CLARKSBURG TOWN CENTER

REVISIONS PLAN

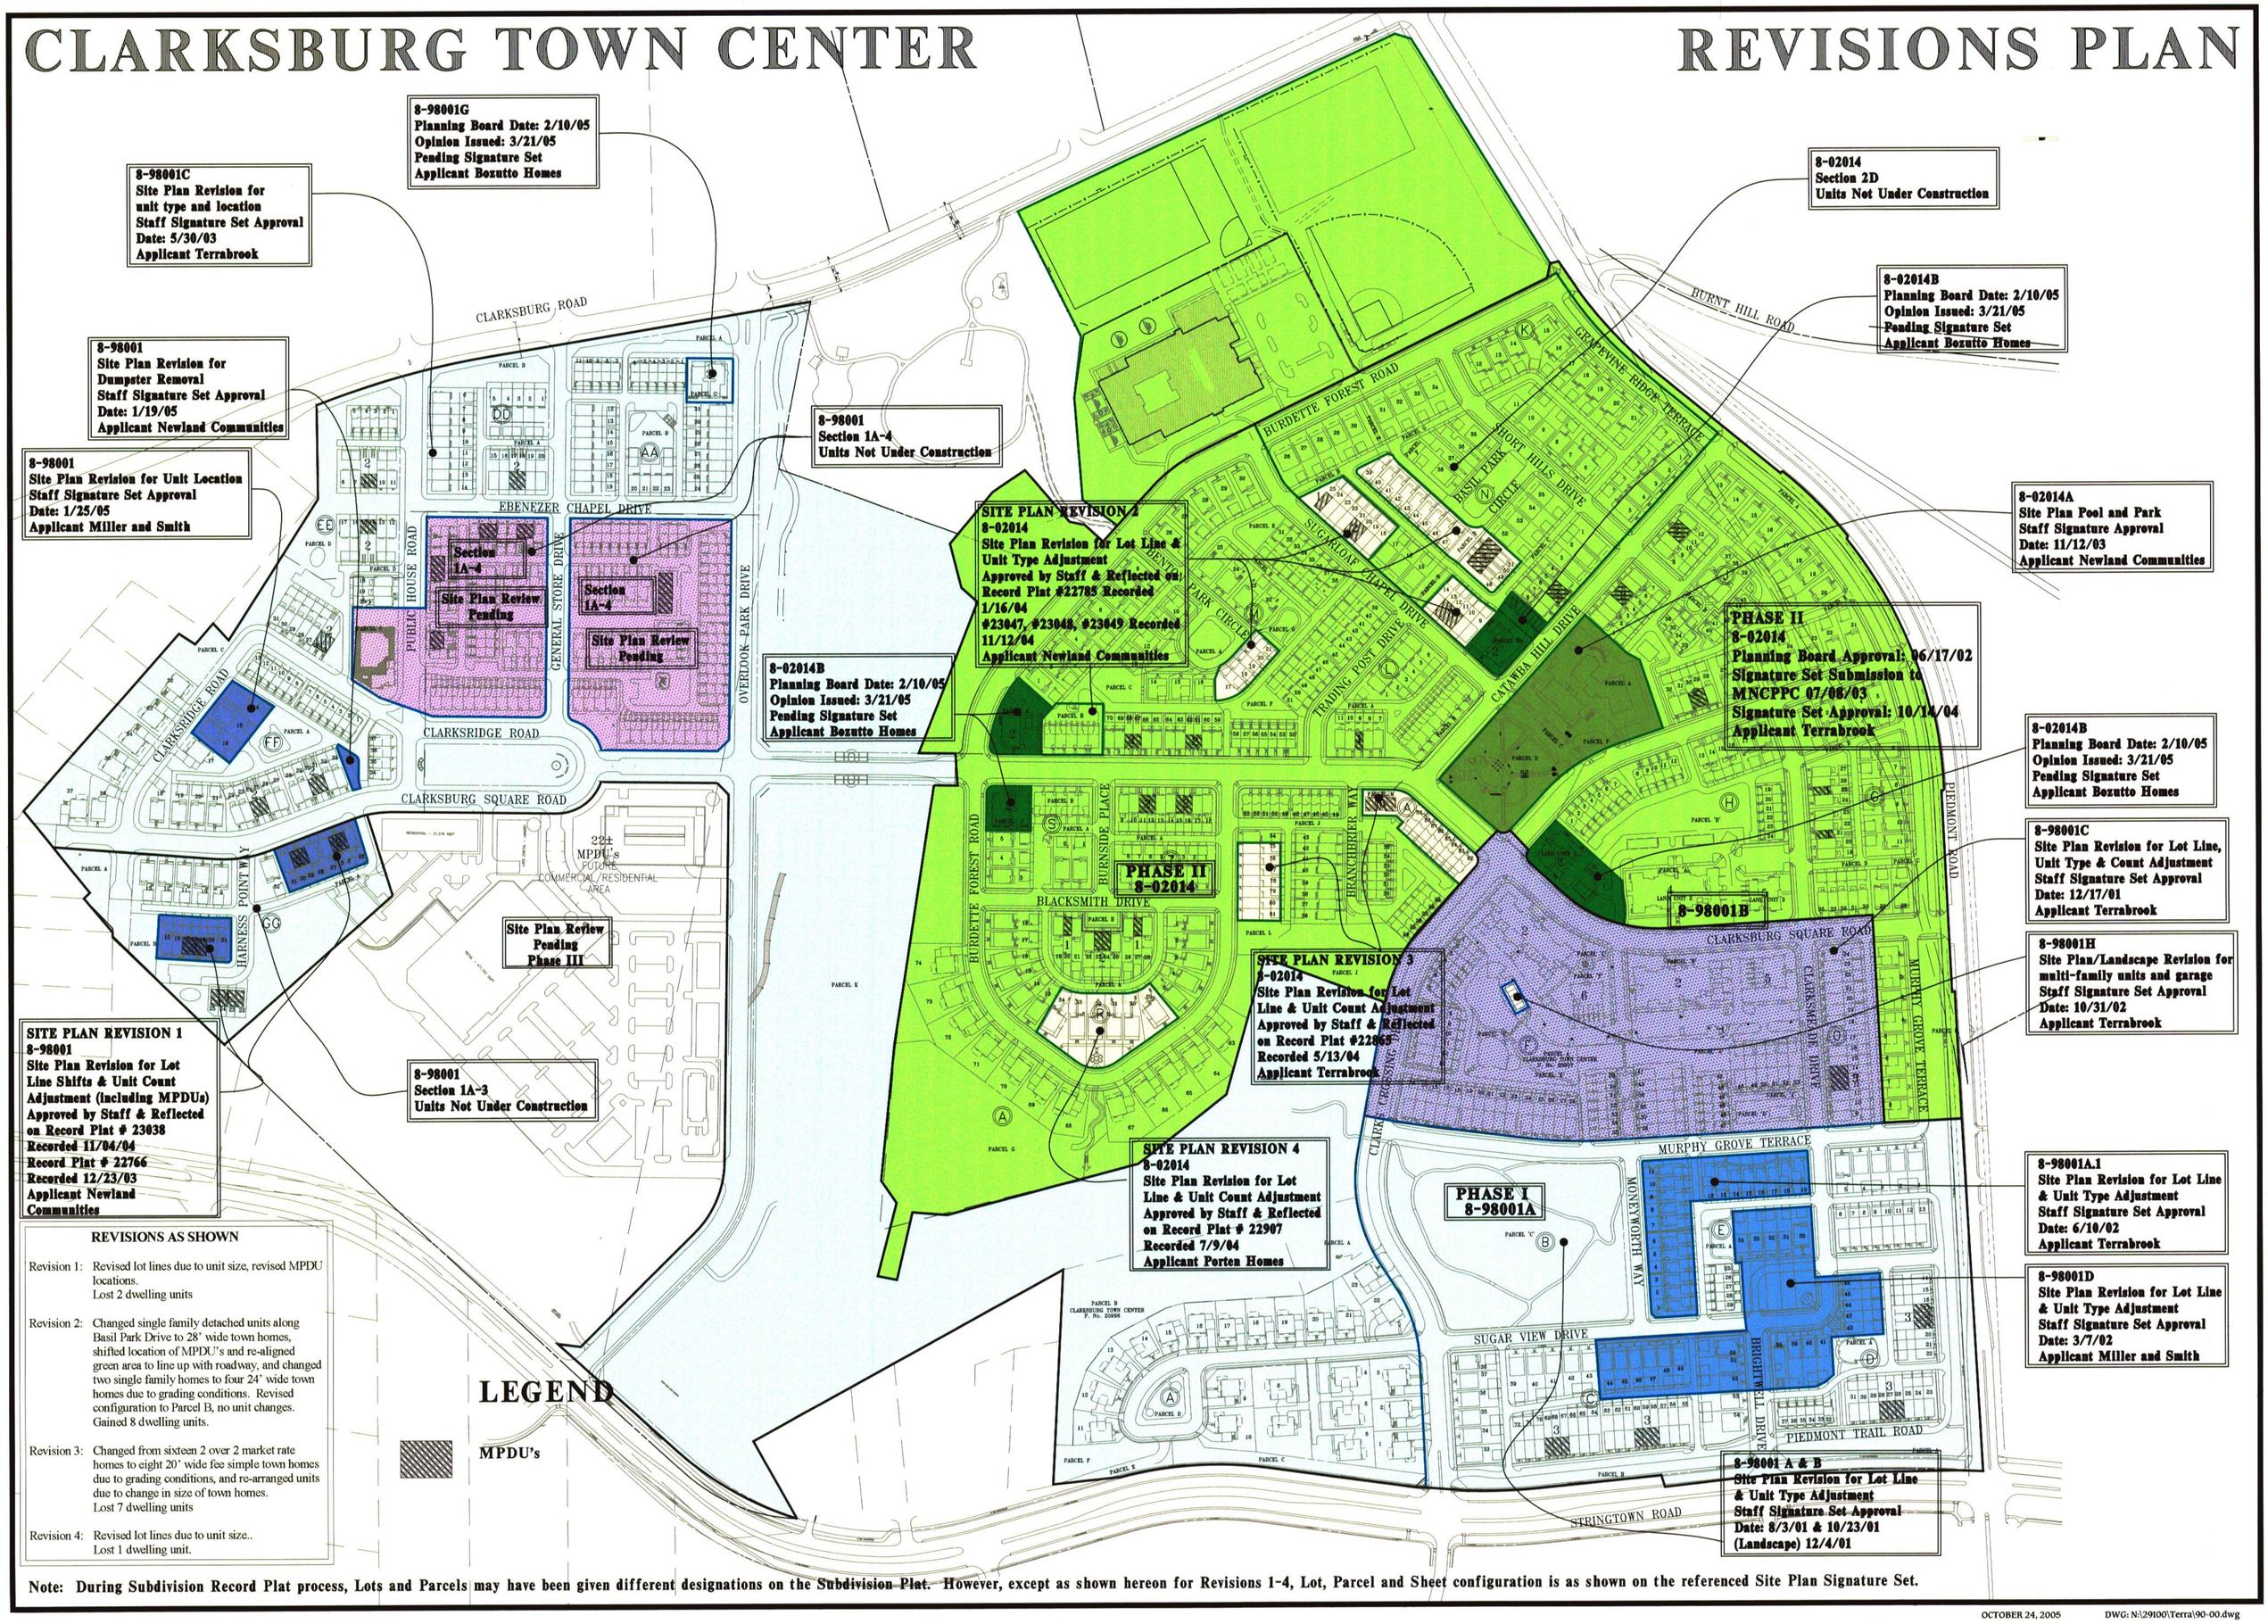
Revision 1: Revised lot lines due to unit size, revised MPDU locations.
Lost 2 dwelling units

Revision 2: Changed single family detached units along Basil Park Drive to 28' wide town homes, shifted location of MPDU's and re-aligned green area to line up with roadway, and changed two single family homes to four 24' wide town homes due to grading conditions. Revised configuration to Parcel B, no unit changes. Gained 8 dwelling units.

Revision 3: Changed from sixteen 2 over 2 market rate homes to eight 20' wide fee simple town homes due to grading conditions, and re-arranged units due to change in size of town homes.
Lost 7 dwelling units

Revision 4: Revised lot lines due to unit size..
Lost 1 dwelling unit.
